APPENDIX H

RETROFIT PLAN FOR MILLERS RIDGE APARTMENTS

A. INACCESSIBLE PUBLIC AND COMMON AREA FEATURES (ADA & FHA)

Millers Ridge: Route to Leasing Office from Site Arrival Points

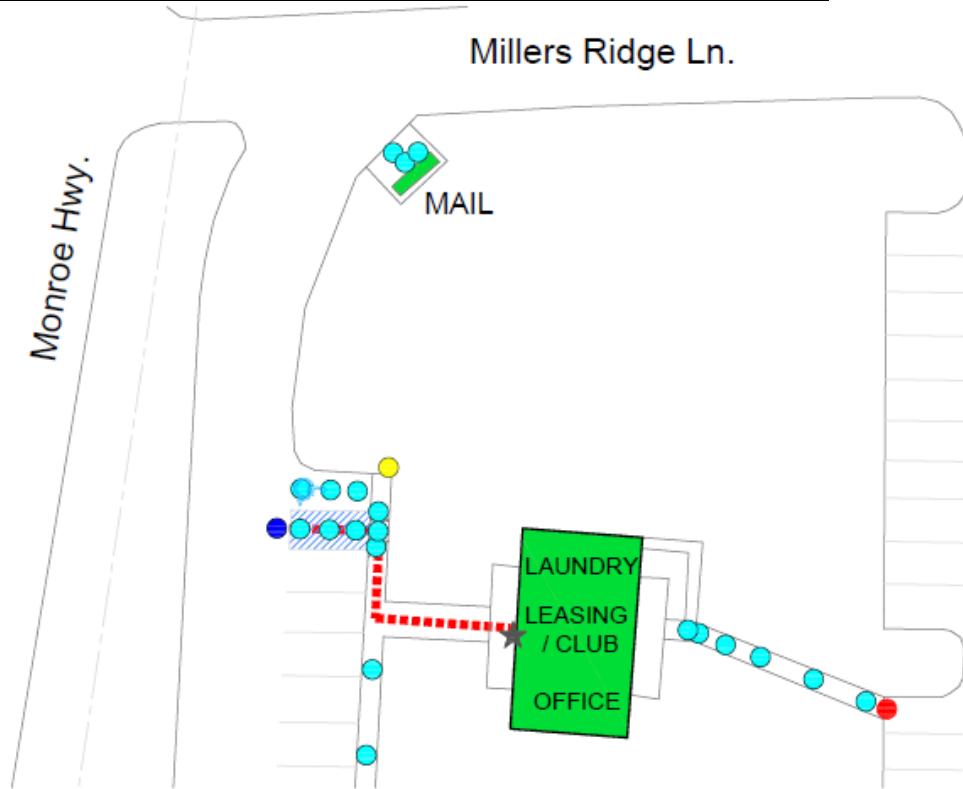
Note: while inaccessible features are shown at 2 routes, retrofits are required to provide only one route to the leasing/clubhouse from pedestrian points of arrival, vehicular points of arrival and all covered dwelling units. If all required routes are provided as is proposed in the Accessible Route Diagram, the walk east of leasing can remain as-is. See Accessible Route Diagram on page 2.

- CHANGE IN LEVEL
- EXCESSIVE CROSS AND/OR RUNNING SLOPE
- ROUTE ENDS AT VEHICULAR WAY
- ROUTE ENDS AT GRASSY AREA

Inaccessible Features at Common Use Routes – Millers Ridge

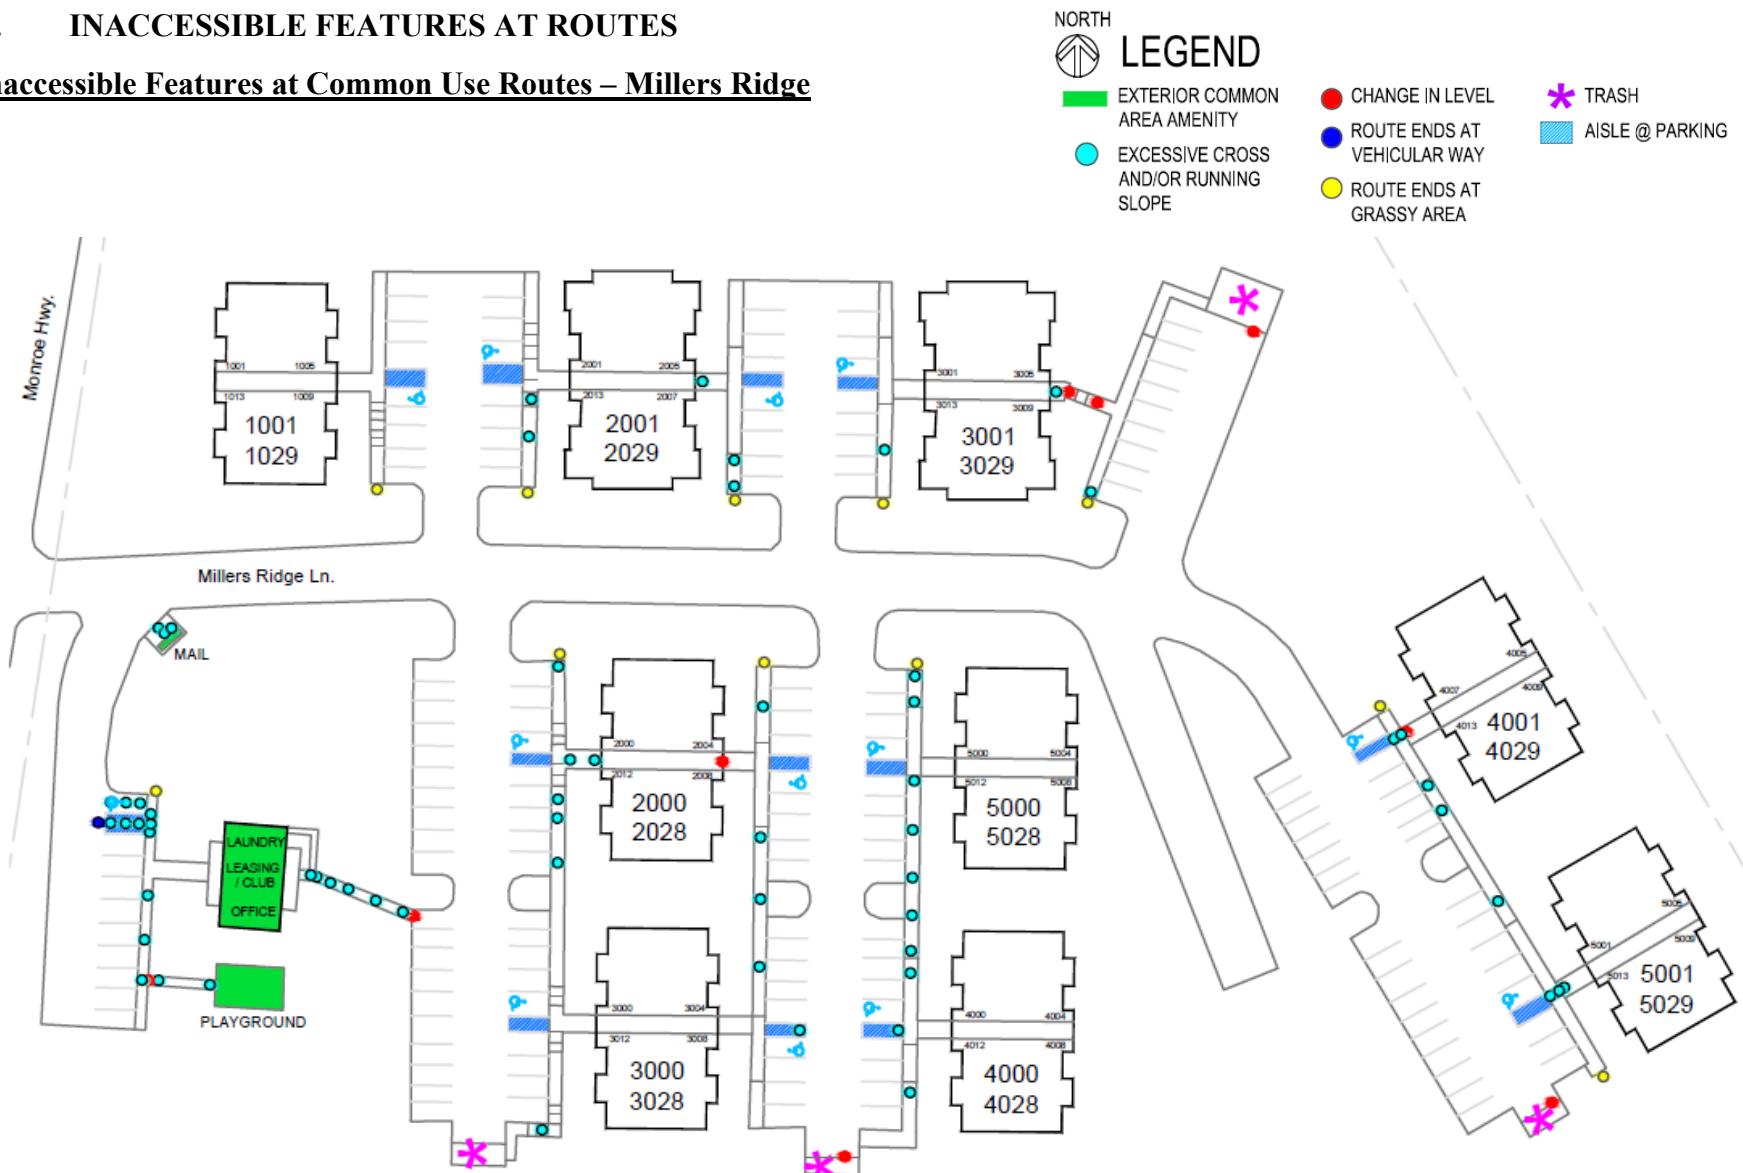
Lack of Accessible Route		
9	 <p><i>No route to east building group</i></p>	<p>There is no accessible route from covered dwelling units to site arrival points, leasing office, and common areas.</p>	<p>Provide new sidewalks and curb ramps from Monroe Highway to existing walks (see Accessible Route Diagram).</p>
10	 <p><i>The sidewalk west of 2001-2029 blocked by a parked vehicle.</i></p>  <p><i>Space between bumper and edge of walk.</i></p>	<p>Sidewalks are not wide enough to provide a 36-inch clear route past parked vehicles (minimum 36 inches required).</p>	<p>Install wheel stops at all parking spaces abutting accessible routes.</p>

Inaccessible Change in Level										
11	 <p><i>Dumpster east of 3001-3029. Measurement of curb.</i></p>	<p>The route has changes in level greater than 1/4 inch (maximum 1/4 inch allowed without a bevel and 1/2 inch with a bevel).</p> <table> <thead> <tr> <th><u>Location</u></th> <th>Height (inches)</th> </tr> </thead> <tbody> <tr> <td>Playground entrance</td> <td>3/4</td> </tr> <tr> <td>West of 4001-4029</td> <td>3/4</td> </tr> </tbody> </table>	<u>Location</u>	Height (inches)	Playground entrance	3/4	West of 4001-4029	3/4	<p>Replace or grind paving at playground entrance, location west of 4001-4029, and approach to trash south of 5001-5029 as required to provide a route that is free of changes in level.</p>		
<u>Location</u>	Height (inches)										
Playground entrance	3/4										
West of 4001-4029	3/4										
11a	 <p><i>Dumpster east of 3001-3029.</i></p>	<p>The route has changes in level greater than 1/4 inch (maximum 1/4 inch allowed without a bevel and 1/2 inch with a bevel) at trash areas.</p> <table> <thead> <tr> <th><u>Location</u></th> <th>Height (inches)</th> </tr> </thead> <tbody> <tr> <td>Trash east of 3001-3029</td> <td>5-3/4</td> </tr> <tr> <td>Trash south of 5001-5029</td> <td>3/4</td> </tr> <tr> <td>Trash south of 4000-4028</td> <td>6-1/4</td> </tr> </tbody> </table>	<u>Location</u>	Height (inches)	Trash east of 3001-3029	5-3/4	Trash south of 5001-5029	3/4	Trash south of 4000-4028	6-1/4	<p>Provide new curb ramp and route to trash dumpsters south of 5001-5029 and south of 4000-4028.</p> <p>Relocate the trash dumpster east of 3001-3029 to the parking area between 2001-2029 and 3001-3029. Provide accessible route to the new location.</p> <p>Note: alternate locations for the trash north of Millers Ridge Lane may be considered. Submit any revisions for approval prior to beginning design or construction.</p>

Unit Plan. (PENDERGRAPH00065).

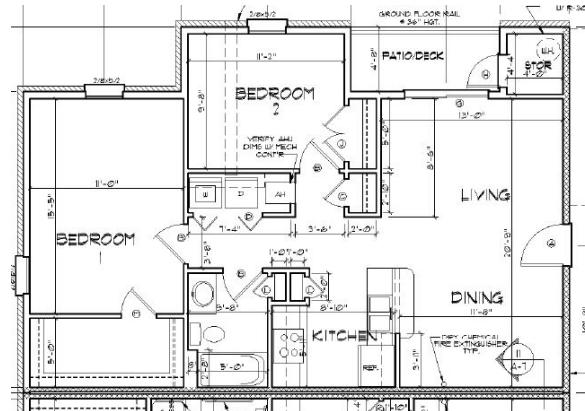
21	 <p>Patio door threshold at Unit 1005.</p>	<p>Door thresholds are more than 3/4 inches high and are not beveled (maximum 3/4 inch with bevel allowed).</p>

22	 <p><i>Kitchen in Unit 1005.</i></p>   <p><i>Measurement of range depth.</i></p>	<p>Outlets above kitchen countertops lack the required clear floor space for approach (at least 1 outlet in each counter area must have a clear floor space). The depth of the range obstructs approach.</p>

<p><i>Vanity base interior in Unit 1005.</i></p>								
25	 <p><i>Bathroom door leaf in open position at Unit 1005.</i></p>	<p>The clear floor space in the bathroom is less than 48-inches long (minimum 48-inches required).</p>

Location	Height (inches)	Unit 1005, patio	7/8	Unit 1005, storage	1-1/2	Unit 3004, patio	1	Unit 3004, storage	1-3/4	<p>Patio and storage closet doors:</p> <p>Provide beveled transition strip or offer remediation upon request of tenants. If offered on tenant request, a durable-material placard, contrasting black text on white background, in minimum 14-point font, must be placed on the side of the patio door stating: "A BEVEL TO ASSIST PERSONS WITH DISABILITIES FOR THIS THRESHOLD IS AVAILABLE UPON REQUEST. CONTACT MANAGEMENT."</p>
Location	Height (inches)												
Unit 1005, patio	7/8												
Unit 1005, storage	1-1/2												
Unit 3004, patio	1												
Unit 3004, storage	1-3/4

<p>Replace range or add outlets on side walls at each side of the counters. New outlets on side walls to be maximum 10 inches back from the front face of the range.</p>	<u>Location</u>	<u>Depth (inches)</u>	Unit 1005	26-7/8	Unit 3004	27 +/-
<u>Location</u>	<u>Depth (inches)</u>							
Unit 1005	26-7/8							
Unit 3004	27 +/-

<u>Location</u>	<u>Distance (inches)</u>	Unit 1005	30-7/8	Unit 3004	31-3/8	<p>Reverse the door so that it does not swing into the bathroom.</p>
<u>Location</u>	<u>Distance (inches)</u>								
Unit 1005	30-7/8								
Unit 3004	31-3/8

Unit Plan. (PENDERGRAPH0065).

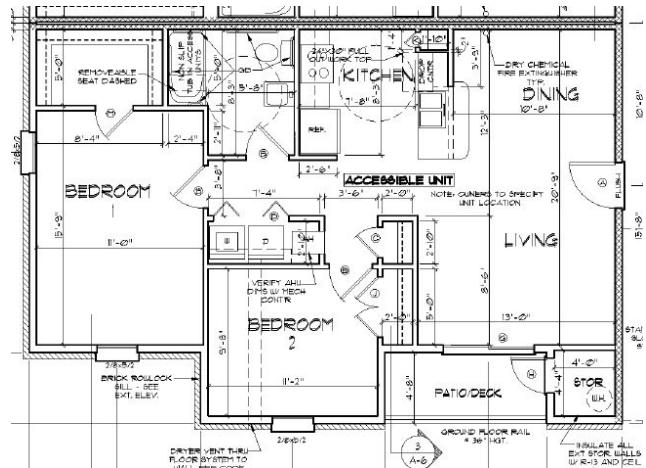
26	 <p><i>Entry door threshold interior side at Unit 1009.</i></p>	<p>Door thresholds are more than 3/4 inches high at the interior face and are not beveled (maximum 3/4 inch with bevel allowed).</p>

WITH DISABILITIES FOR THIS THRESHOLD IS AVAILABLE UPON REQUEST. CONTACT MANAGEMENT.”
27	 <p><i>Bathtub/shower surround in Unit 1009.</i></p>	<p>The shape of the bathtub surrounds precludes the installation of future grab bars with firm attachment to blocking (ability to install grab bars required).</p>	<p>Replace tub surround or install custom grab bars on request that can be mounted in the required locations at the existing surrounds.</p>

<u>Location</u>	<u>Height (inches)</u>	Unit 1009 entry	7/8	Unit 1009 patio	1-1/8	<p>Unit entry door: Install threshold transition strips at each side of each location or replace threshold.</p> <p>Patio doors: Provide beveled transition strip or offer remediation upon request of tenants. If offered on tenant request, a durable-material placard, contrasting black text on white background, in minimum 14-point font, must be placed on the side of the patio door stating: "A BEVEL TO ASSIST PERSONS</p>
<u>Location</u>	<u>Height (inches)</u>								
Unit 1009 entry	7/8								
Unit 1009 patio	1-1/8

Unit Plan. (PENDERGRAPH00066).

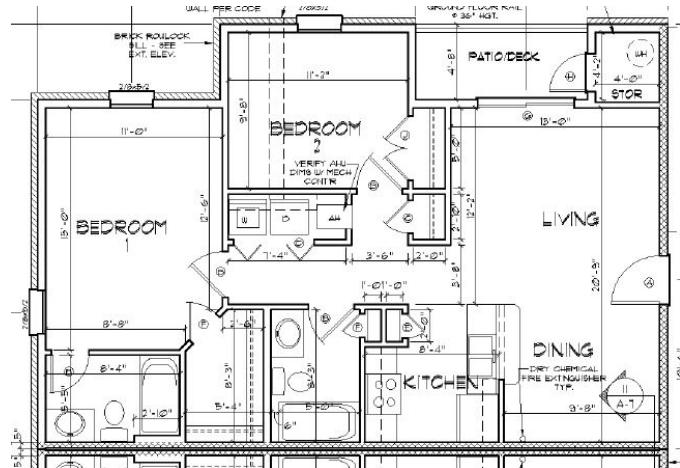
28	 <p>Countertop adjacent to range in Unit 2004.</p>	<p>Outlets above kitchen countertops lack the required clear floor space for approach (at least 1 outlet in each counter area must have a clear floor space). The depth of the range obstructs approach.</p>

29	 <p><i>Bathtub/shower surround in Unit 2004.</i></p>	<p>The shape of the bathtub surrounds precludes the installation of future grab bars with firm attachment to blocking (ability to install grab bars required).</p>	<p>Replace tub surround or install custom grab bars on request that can be mounted in the required locations at the existing surrounds.</p>										
30	 <p><i>Measurement to centerline of master bathroom lavatory in Unit 5004.</i></p>	<p>Lavatory centerlines are less than 24 inches to the side wall (minimum 24 inches required) and the cabinets are not removable.</p>

<p><i>Interior of vanity cabinet in Unit 5004.</i></p>												
31	 <p><i>Hall bathroom door leaf in open position at Unit 2004.</i></p>	<p>The clear floor space in the bathroom is less than 48 inches long (minimum 48-inches required).</p>

Location	Depth (inches)	Unit 2004	27 +/-	Unit 5004	27 +/-	<p>Replace range or add outlets on side walls at each side of the counters. New outlets on side walls to be maximum 10 inches back from the front face of the range.</p>
Location	Depth (inches)								
Unit 2004	27 +/-								
Unit 5004	27 +/-

<u>Location</u>	Distance (inches)	Unit 2004 hall bathroom	15-1/2	Unit 2004 master bathroom	15-3/4	Unit 5004 hall bathroom	15-3/8	Unit 5004 master bathroom	15-1/2	<p>Install removable base cabinet with 30 inch wide knee space in compliance with safe harbor knee and toe clearance requirements.</p> <p>Attach a durable-material placard stating: "THIS CABINET IS REMOVABLE FOR PERSONS WITH DISABILITIES. CONTACT MANAGEMENT."</p>
<u>Location</u>	Distance (inches)												
Unit 2004 hall bathroom	15-1/2												
Unit 2004 master bathroom	15-3/4												
Unit 5004 hall bathroom	15-3/8												
Unit 5004 master bathroom	15-1/2

<u>Location</u>	Distance (inches)	Unit 2004 hall bathroom	31	Unit 2004 master bathroom	30	Unit 5004 hall bathroom	31-1/4	Unit 5004 master bathroom	27	<p>Reverse the door so that it does not swing into the bathroom.</p>
<u>Location</u>	Distance (inches)												
Unit 2004 hall bathroom	31												
Unit 2004 master bathroom	30												
Unit 5004 hall bathroom	31-1/4												
Unit 5004 master bathroom	27

Dimension from door leaf in open position to bathtub.

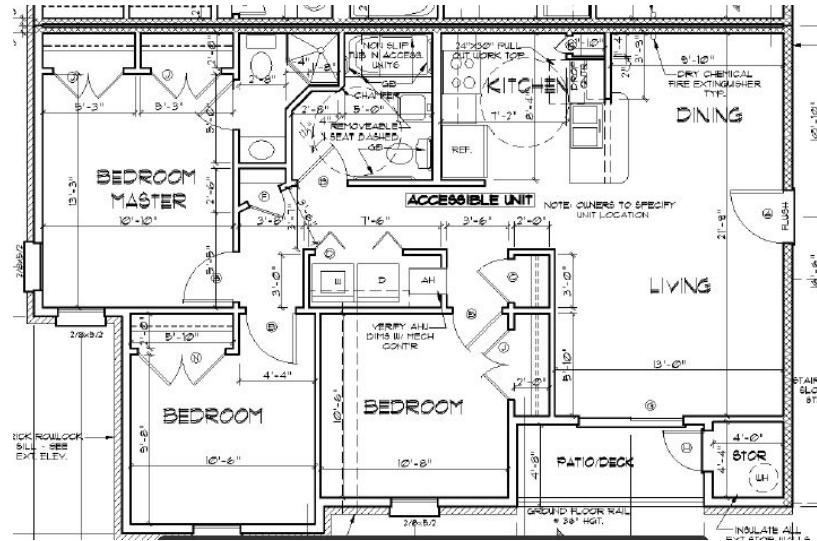
36	 <p><i>Measurement to hall bathroom toilet centerline in Unit 2001</i></p>	<p>Toilet centerlines are less than 18 inches to the bathtub on the side opposite the direction of approach (minimum 18 inches required).</p> <table> <thead> <tr> <th data-bbox="688 393 868 425"><u>Location</u></th><th data-bbox="1100 355 1227 425">Distance (inches)</th></tr> </thead> <tbody> <tr> <td data-bbox="688 425 1079 458">Unit 2001 master bathroom</td><td data-bbox="1100 425 1227 458">12-1/4</td></tr> </tbody> </table>	<u>Location</u>	Distance (inches)	Unit 2001 master bathroom	12-1/4	<p>Install offset flange at master bathroom to shift toilet centerline to a position as close to 18 inches from the tub as is possible without requiring changes to the waste line or flooring.</p>				
<u>Location</u>	Distance (inches)										
Unit 2001 master bathroom	12-1/4										
37	 <p><i>Bathroom door leaf in open position at Unit 2001.</i></p>	<p>The clear floor space in the bathroom is less than 48 inches long (minimum 48-inches required).</p> <table> <thead> <tr> <th data-bbox="688 943 868 975"><u>Location</u></th><th data-bbox="1100 905 1227 975">Length (inches)</th></tr> </thead> <tbody> <tr> <td data-bbox="688 975 1079 1008">Unit 2001 hall bathroom</td><td data-bbox="1100 975 1227 1008">32</td></tr> <tr> <td data-bbox="688 1008 1079 1041">Unit 2001 master bathroom</td><td data-bbox="1100 1008 1227 1041">24-3/8</td></tr> <tr> <td data-bbox="688 1041 1079 1073">Unit 2005 hall bathroom</td><td data-bbox="1100 1041 1227 1073">32</td></tr> </tbody> </table>	<u>Location</u>	Length (inches)	Unit 2001 hall bathroom	32	Unit 2001 master bathroom	24-3/8	Unit 2005 hall bathroom	32	<p>Reverse the door so that it does not swing into the bathroom.</p>
